# CITY PLANNING COMMISSION

APPLICATION: A. Negative Declaration  
B. Special Permit Modification to allow revisions to the elevation and building configuration of a private school (pre school to grade six).

LOCATION: 7400 Pocket Road

Special Permit Modification

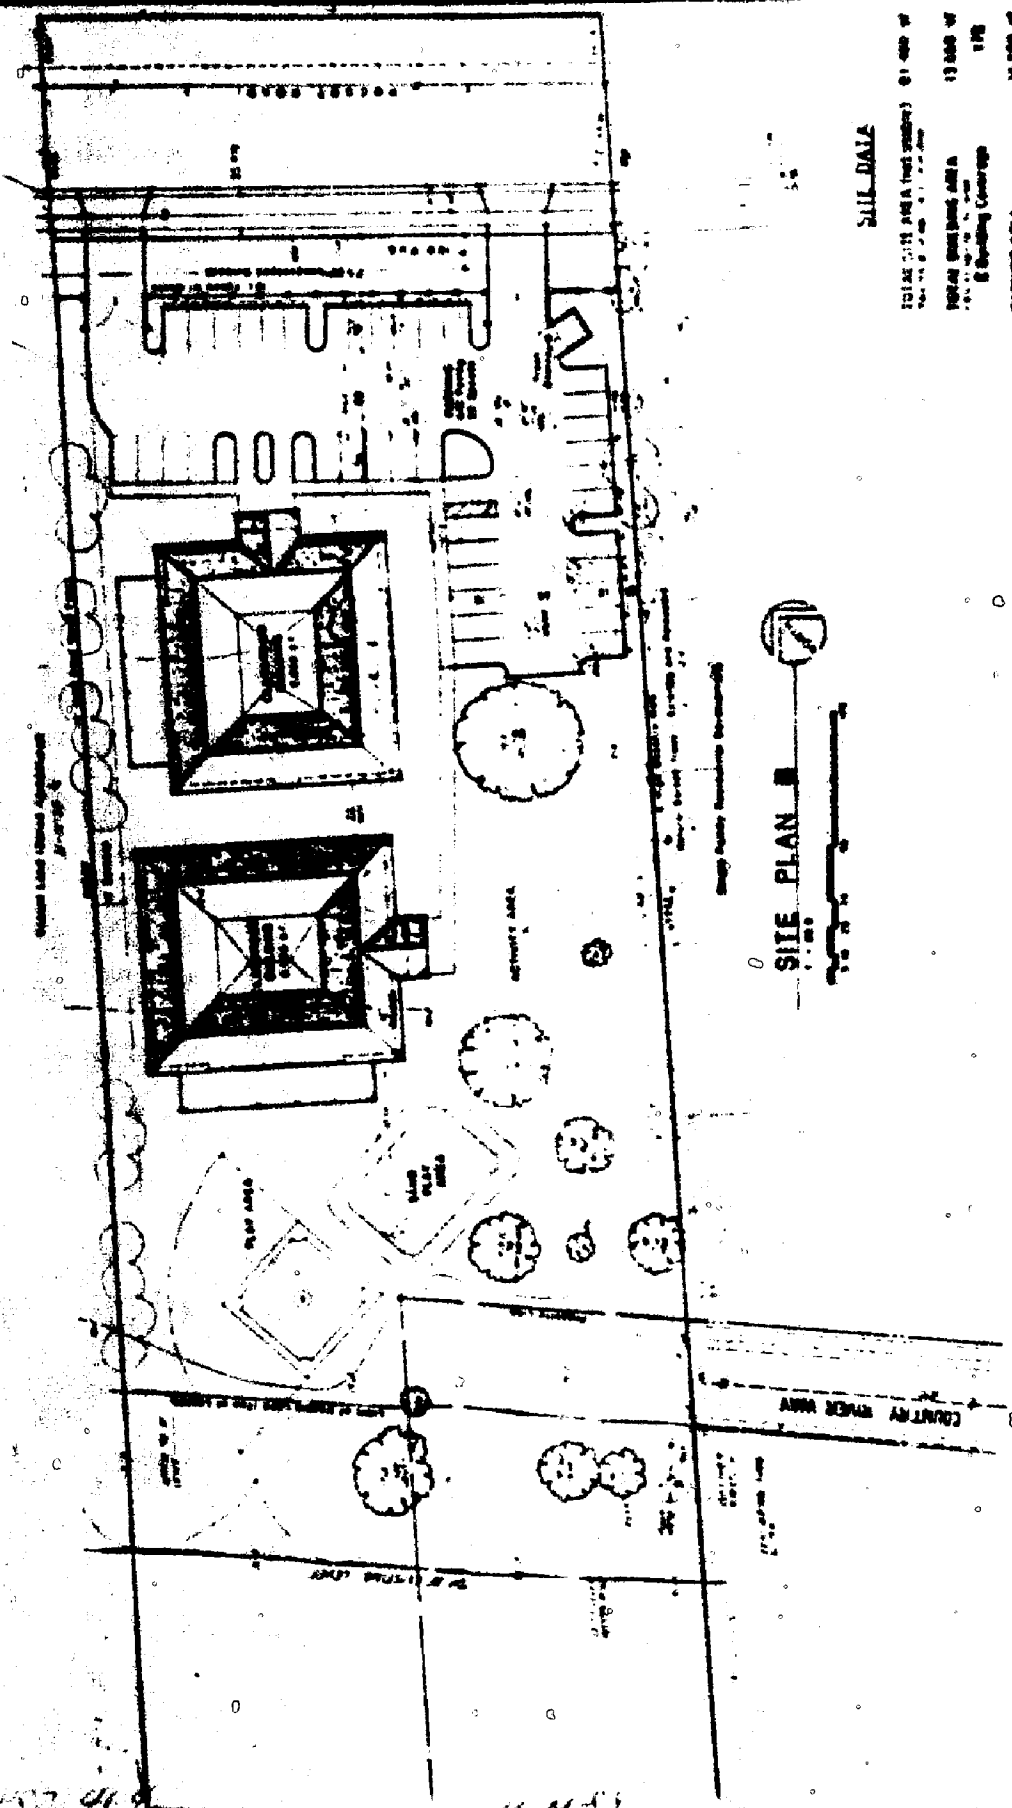
The applicant has submitted two alternative site plans. Staff, as well as the applicant, prefers site Plan A. This site plan spreads the two buildings apart with the play and activity areas situated between the buildings. A 10 ft. building setback is indicated on both the north

... recommendations increasing the setback  
... property 10 to 15 ft. This should not create  
... for the play/activity areas and will help alleviate an  
... impacts associated with the single family development

The sand play area should be reoriented 90 degrees to a  
alignment. The reorientation will keep noise levels down  
adjacent property to the north which could be developed with  
in the future. Staff recommends heavy landscaping around the  
enclosure with a berm up against the outside wall of the  
enclosure.

1. A loud speaking system shall be allowed.
2. Outdoor play equipment (metal) rings which create noise shall be allowed.
3. A 15 foot building setback shall be maintained along the south property line.

4. The sand play area shall be reoriented 90 degrees to the satisfaction of the Planning Director.
5. The trash enclosure shall have heavy landscaping along the outside walls of the enclosure, as indicated on the submitted landscape plan.

6. Site Plan A, as modified, shall be the utilized plan.
7. Revised building elevations shall be submitted for review and approval by the Planning Director prior to issuance of any building permits. Revised elevations shall include the following modifications:

- a. redesign the entry - incorporate column elements at the entrance and at the corners of the building;
  - b. roof - concrete or ceramic tile shall be utilized to bring the roof into compatibility with surrounding residential structures;

- c. windows - aluminum sliders shall have greater width to the metal trim to give more scale and definition to window openings;
  - d. eaves - redesign the fascia to provide a more finished detail;

- e. the side elevations shall be compatible to the front elevation;
  - f. the quality of wood siding shall be improved over that which was observed at the Rocklin Merryhill site. The grade of the lumber shall be detailed on plans;
